Your Ref
M/61/14/PL
Our Ref
PLAN-007302
Date
17/09/2014

Proposal: Conversion of existing residence into 3 No new flats (resubmission following M/13/14/).

Site: The Litten, Ancton Lodge Lane, Bognor Regis, PO22 6LZ.
M/61/14/PL

Southern Water MapGuide Browser

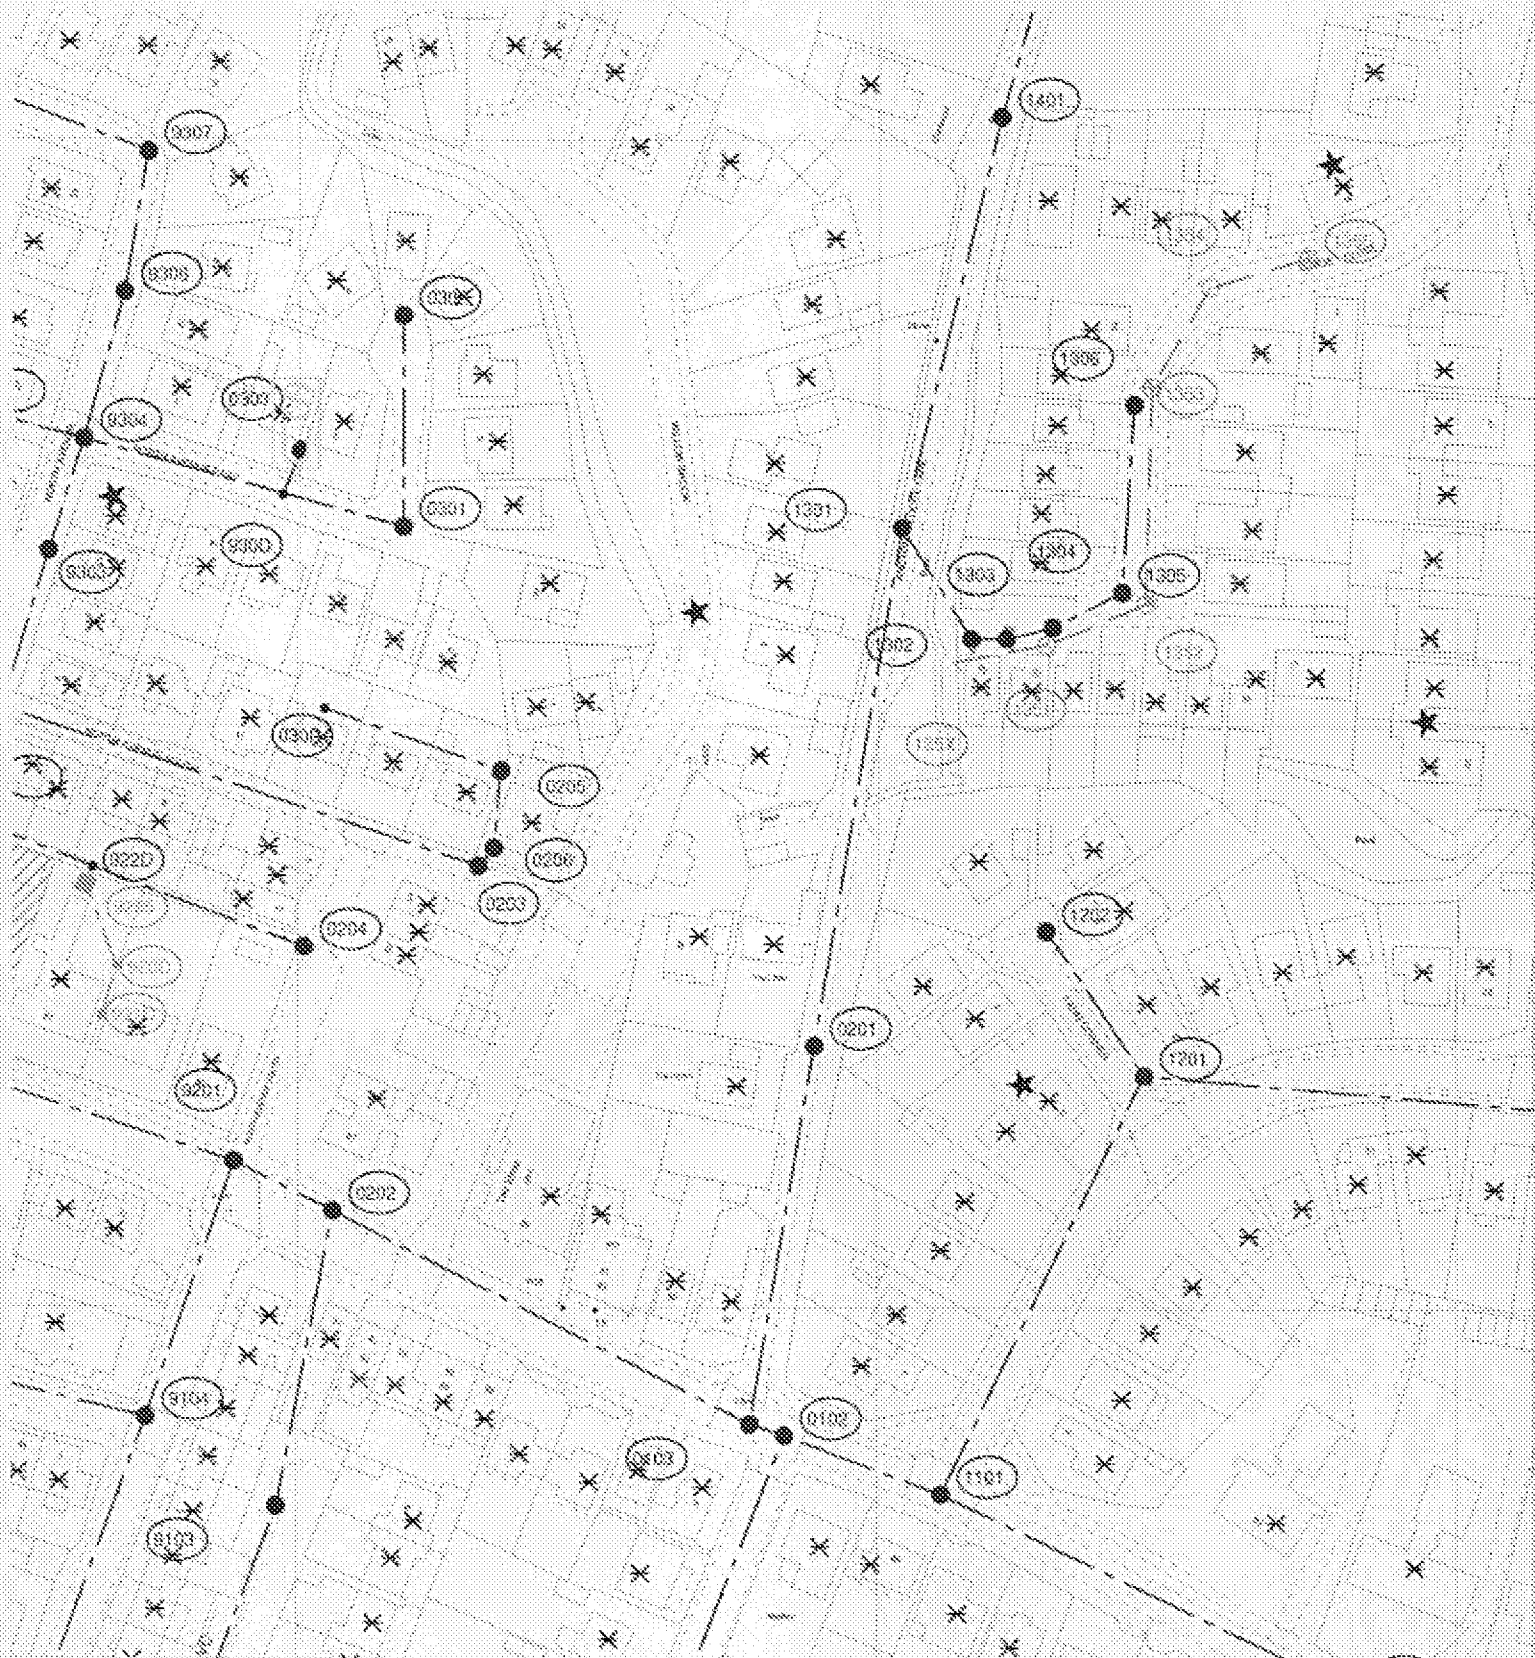
Due to changes in legislation that came in to force on 1st October 2011 regarding the future ownership of sewers it is possible that a sewer now deemed to be public could be crossing the above property. Therefore, should any sewer be found during construction works, an investigation of the sewer will be required to ascertain its condition, the number of properties served, and potential means of access before any further works commence on site. The applicant is advised to discuss the matter further with Southern Water, Sparrowgrove House, Sparrowgrove, Otterbourne, Hampshire SO21 2SW (Tel: 0330 303 0119) or www.southernwater.co.uk.
